100GBASE-BR40: Update to Tables

IEEE802.3dk July 2024 meeting

New Proposal for Outer Optical Modulation Amplitude

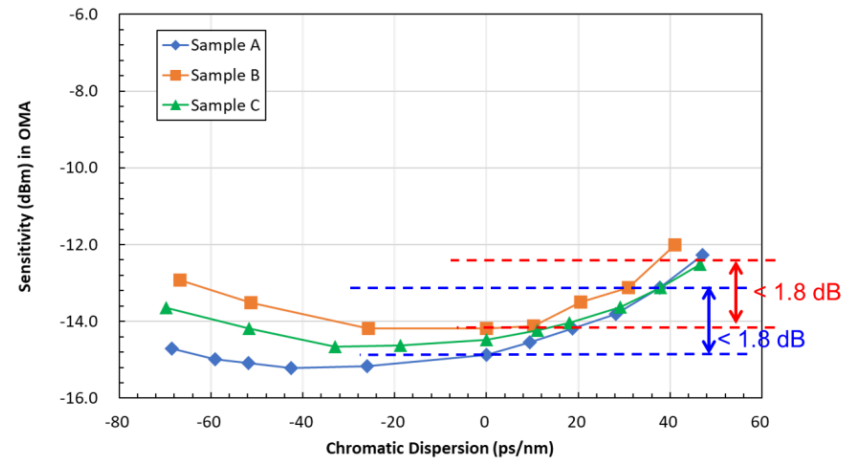
- At the June e-meeting we proposed APD OMA Sensitivity for 100GBASE-BR40.
- In this contribution, “Outer Optical Modulation Amplitude” will be proposed clearly.
- Transmitter parameters will be revised according to the receiver sensitivity proposed at the June meeting.

Outer Optical Modulation Amplitude (OMA _{outer}) (min):		Receiver sensitivity(OMA _{outer})(max)		Unit
	for TDECQ < 1.4 dB	for 1.4 dB \leq TDECQ \leq 3.9 dB or TDECQ (max)	for TECQ < 1.4 dB	for 1.4 dB \leq TECQ \leq 3.9 dB or TDECQ (max)	
Baseline	5.7	4.3 + TDECQ	-12.8	-14.2 + TECQ	dBm
Proposal on April Meeting	4.7	3.3 + TDECQ	-13.8	-15.2 + TECQ	dBm
Proposal on June Meeting	5.0	3.6 + TDECQ	-13.5	-14.9 + TECQ	dBm
New Proposal	5.3	3.9 + TDECQ	-13.2	-14.6 + TECQ	dBm
